Addendum No. 1

Subject: JAMES RHOADS ELEMENTARY SCHOOL
CLASSROOM MODERNIZATION
SDP CONTRACT NOS. B-033C, B-035 CC

This Addendum, ***dated 9th of May 2018***, shall modify and become part of the Contract Documents for the work of this project. Any items not mentioned herein, or affected by, shall be performed strictly in accordance with the original documents.

| THE SHEWARD PARTNERSHIP IN ASSOCIATION WITH PRINCETON ENGINEERING SERVICES, PC | | | ASK-P1 | |

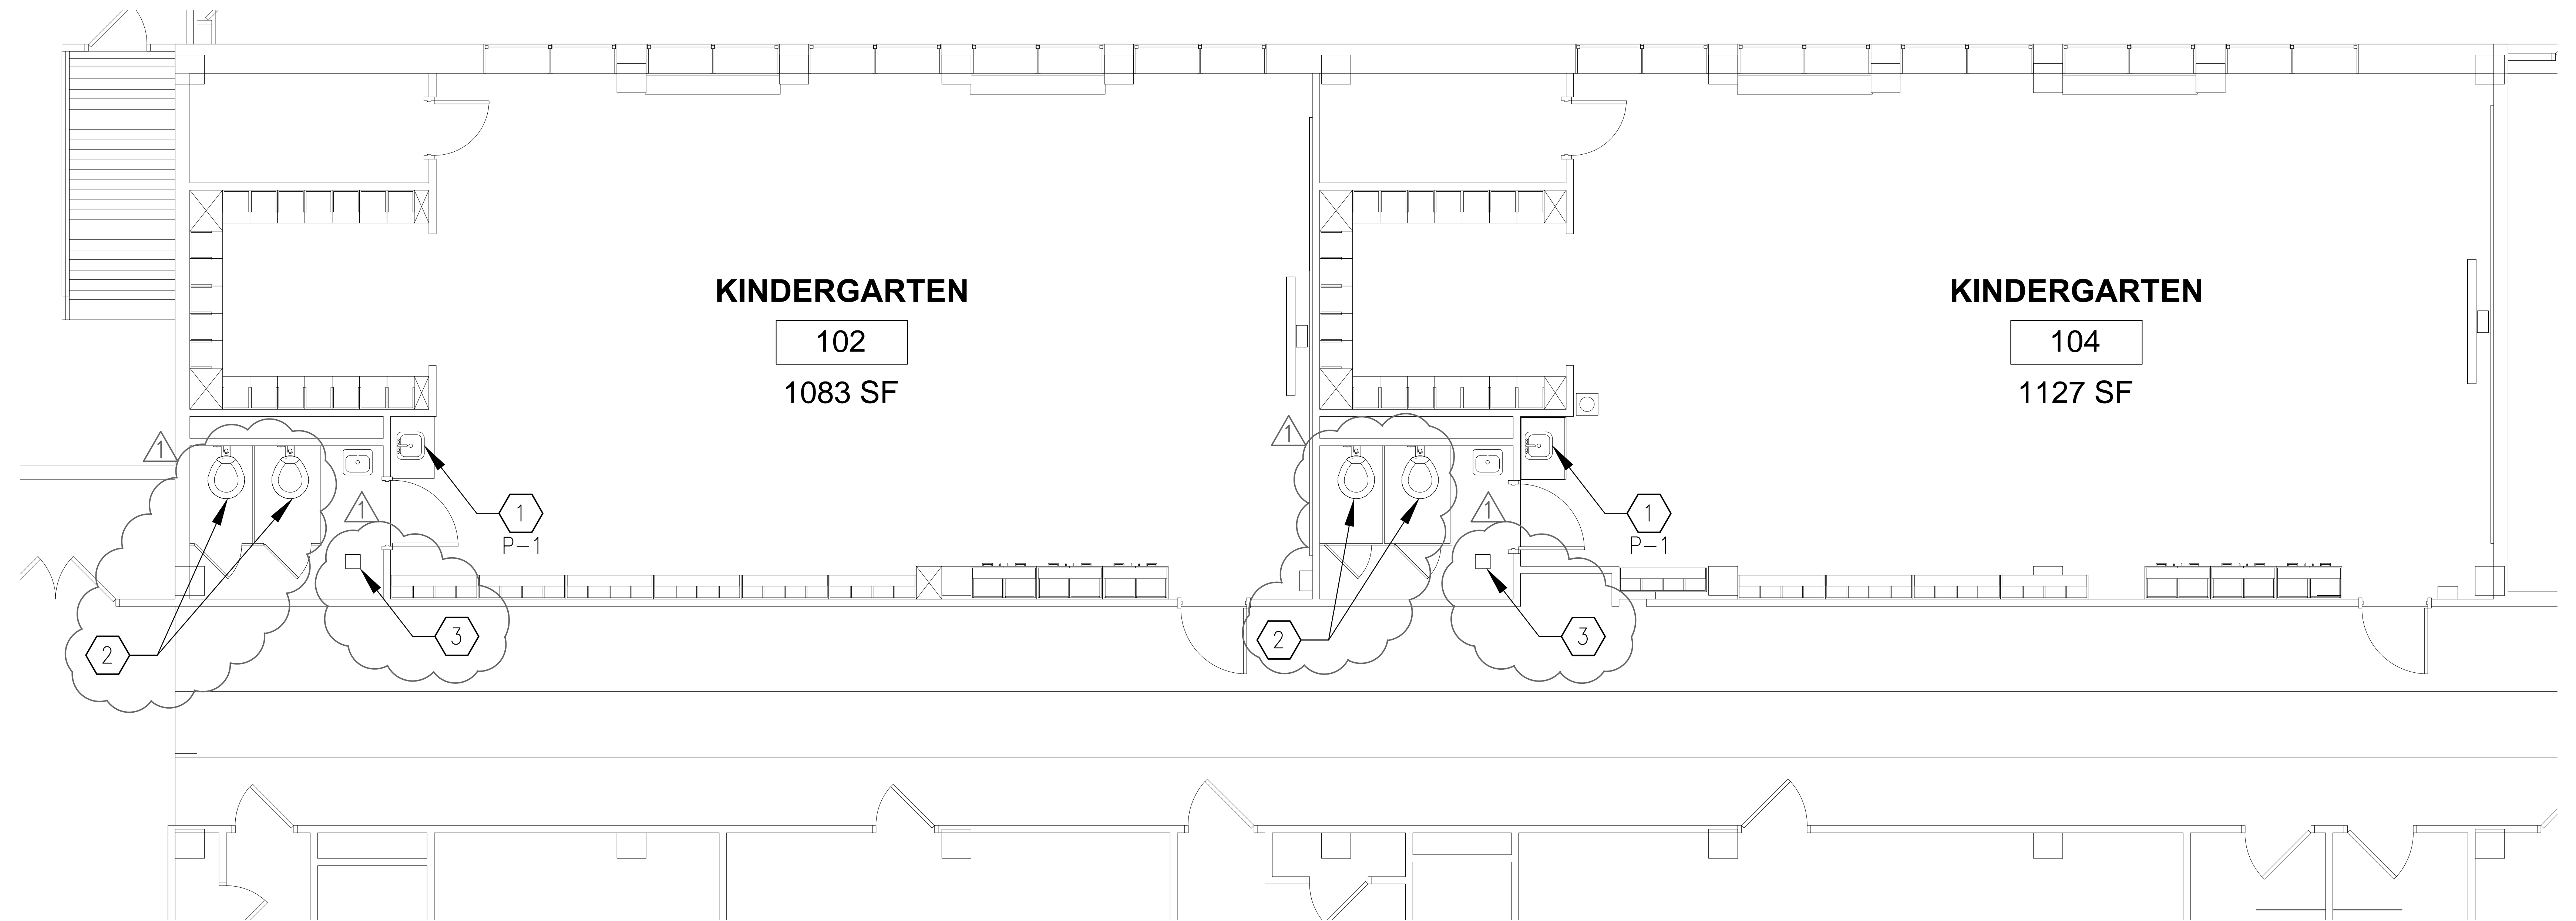
| ASK-P1 | FIRST FLOOR PLUMBING PART PLAN |

PLUMBING KEY NOTES

1 DISCONNECT EXISTING SINK INCLUDING BUT NOT LIMITED TO SANITARY, DOMESTIC COLD & HOT WATER, VENT & REMOVE EXISTING SINK, FAUCET & TRIMS. PROVIDE NEW VALVES AND CAP WATER AND LINES SECURELY PRIOR TO SUBSTANTIAL COMPLETION. PROVIDE NEW SINK AND ACCESSORIES AS SPECIFIED & REQUIRED & RECONNECT TO EXISTING SANITARY, DOMESTIC COLD & HOT WATER PIPING & VENT. EXTEND & REPLACE EXISTING PLUMBING PIPING AS REQUIRED TO MAKE THE NEW FIXTURE FULLY FUNCTIONAL.

2 DISCONNECT EXISTING WATER CLOSET INCLUDING BUT NOT LIMITED TO SANITARY, DOMESTIC COLD WATER, VENT & SECURE FOR RE-INSTALLATION AFTER NECESSARY GC WORK IS COMPLETED. THE CONTRACTOR SHALL COORDINATE WITH GC & RE-INSTALL THE FIXTURE. EXTEND AND/OR PROVIDE NEW PLUMBING PIPING, FLUSH VALVE TO MATCH EXISTING AND ACCESSORIES REQUIRED TO MAKE THE FIXTURE FULLY FUNCTIONAL.

3 FIELD VERIFY EXACT LOCATION & REMOVE & REPLACE EXISTING FLOOR DRAIN AND ASSOCIATED SANITARY TRAP & PIPING TO THE EXTENT REQUIRED TO INSTALL AND CONNECT NEW FLOOR DRAIN. COORDINATE WORK WITH EXISTING CONDITIONS AND GC. NEW FLOOR DRAIN SHALL BE JAY R SMITH 2050; SIZE TO MATCH EXISTING FLOOR DRAIN.

ELECTRICAL PANEL SHROUD DETAIL

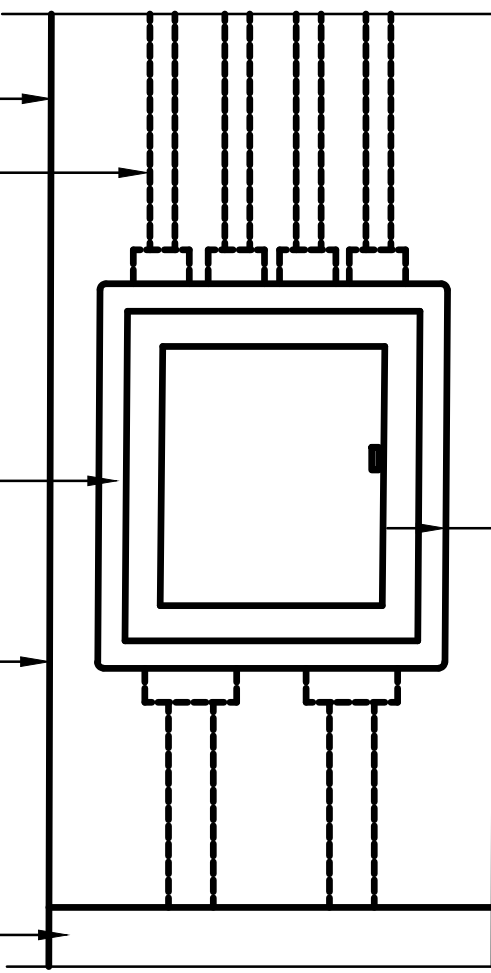
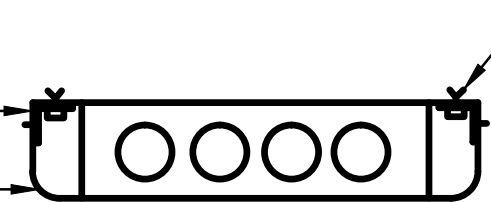
| ASK-E2 | ELECTRICAL PANEL SHROUD DETAIL |

14 GAUGE STEEL SHROUD
FINISH TO MATCH PANEL.

6" STAINLESS STEEL
KICKPLATE ON ALL THREE
SIDES

SIDE OF SHROUD SHALL BE
2" FROM EDGE OF PANEL
COVER

STEEL SHROUD SHALL BE SCREWED TO
ANGLE WITH TAMPER PROOF STAINLESS
STEEL FASTENERS. (TYP.)

2"X2" AND 1/2" THICK STEEL
ANGLE & BOLTED TO WALL
WITH STAINLESS STEEL
FASTENERS. (TYP.)

Metal Box Speakers

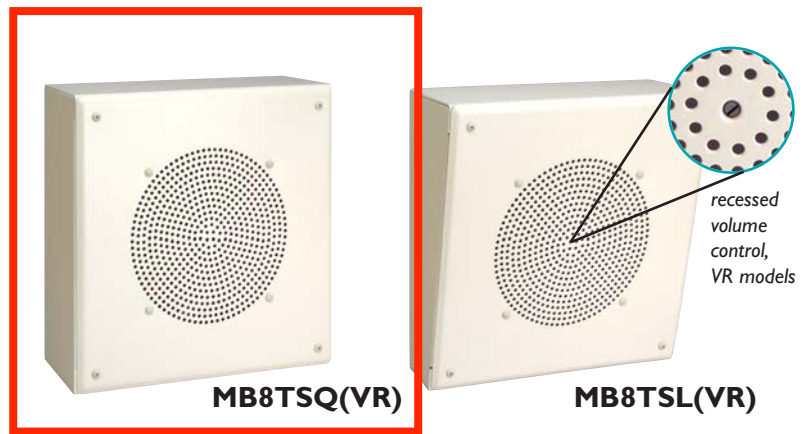
- .9 Clarification: Application has been made to L&I for building permit.**
- .10 Clarification: Where EC is to replace non-functioning speakers and wall telephones the EC shall provide the speakers (see attached cut sheet). SDP will furnish new telephone handsets for installation by EC.**
